## SERVICE BULLETIN

**APPLICABILITY:** 2015-16MY Legacy and Outback Models Equipped with Navigation and Harman Kardon Power Amplifier  
**NUMBER:** 15-194-16  
**DATE:** 02/29/16  
**SUBJECT:** Fujitsu 10/ FTEN/ F10 Navigation Voice Guidance Instructions Getting Cut Off

### PRODUCTION CHANGE INFORMATION:

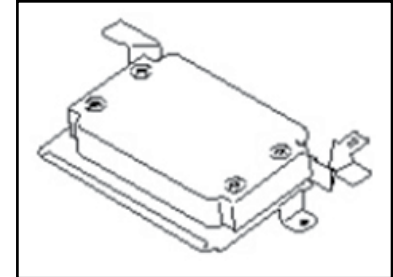
**IMPORTANT:** Regardless of the part number shown on the label, power amplifiers which have a green dot next to the identification label as shown in the photo at the top of page 2, already contain this new software.

The new power amplifier part number is **86221AL71B**.
